Site Development Plan - Comment Response Letter

Citizen on Constitution
El Paso County, Colorado

PCD File Number: PPR-2229

SITE DEVELOPMENT PLAN – COMMENT RESPONSE

2 MONUMENT SIGN LAYOUT
L611 PLAN VIEW

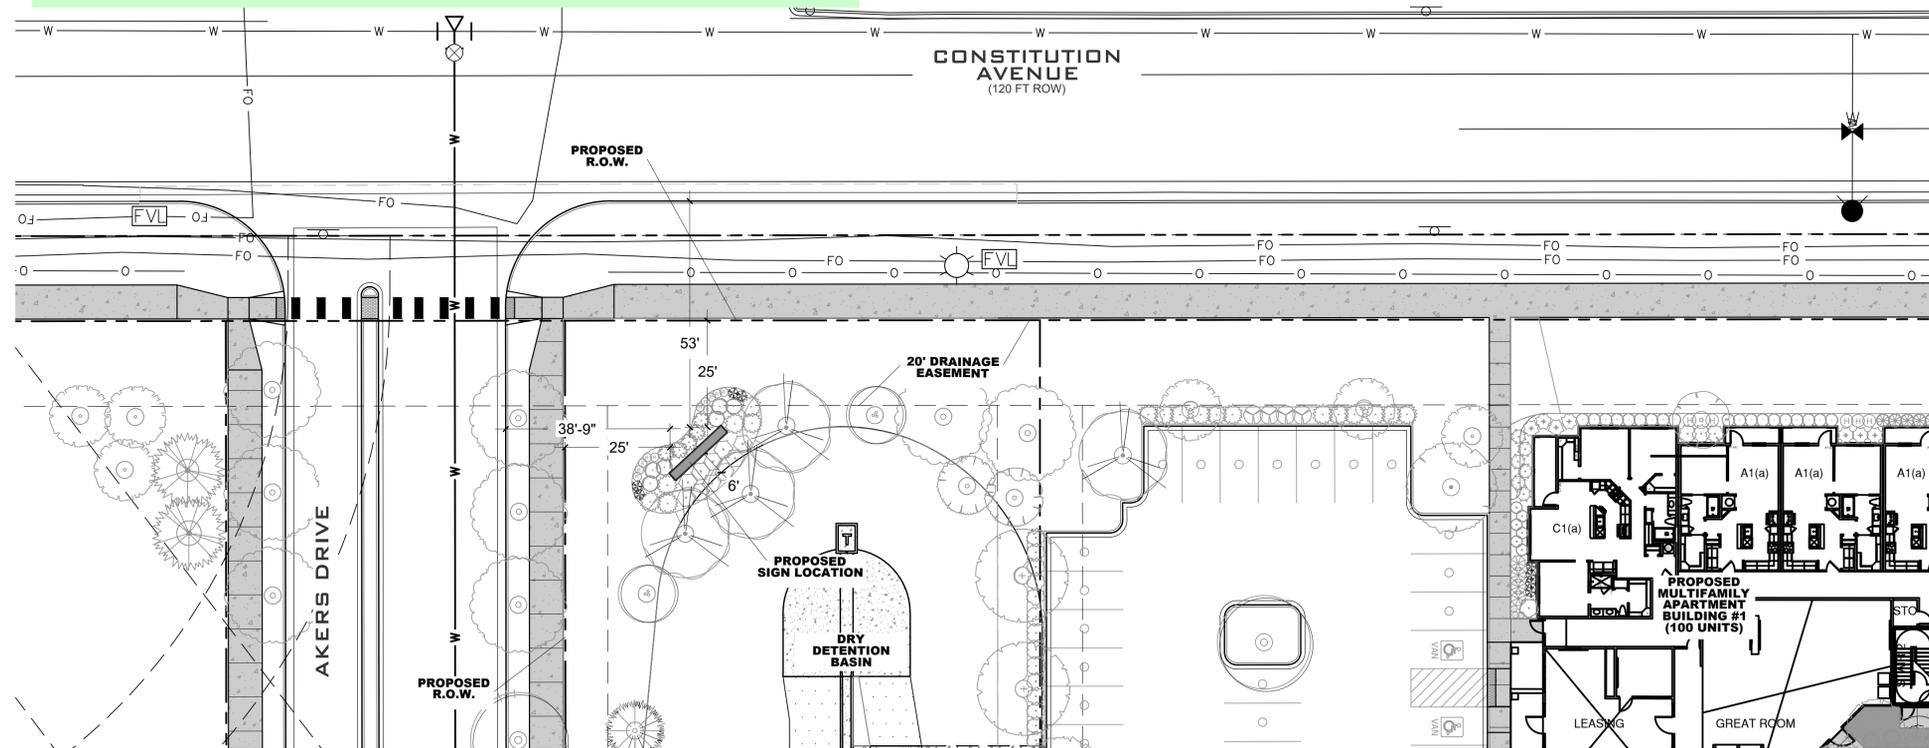
Please include:
 -north arrow
 -vicinity map showing the property in relation to major roadways
 -the outlines of all buildings showing their proposed uses, setbacks, dimensions, and points of access in relation to the lot configuration
 -depiction of any sidewalks, fences, walls, or berms located near any existing or proposed freestanding signs
 -depiction of any loading and other vehicles use areas located near any existing or proposed signs
 -intensity for all outdoor illumination for the sign
 -depiction of any no-build areas and floodplains, if none please specify
 -depiction of all garbage receptacles located near any existing or proposed freestanding signs
 -depiction of all utility lines and associated infrastructure near the proposed signs
 -summary of sq ft of the total signage and existing and proposed signage for the property
 -detailed description of illuminating devices and how the proposed illumination will be in compliance with the lighting standards Section 6.2.3 of LDC

Thank you for your review.
 Additional information has been added to the Sign Plan.
 Please note that this plan is the sign plan and not the Site Plan. The list to the left requests the addition of elements on this plan that do not relate to the sign plans (no-build areas, floodplains, building setbacks, etc.) Please refer to the site and utility plans for other elements which may not be highlighted on the sign plan.
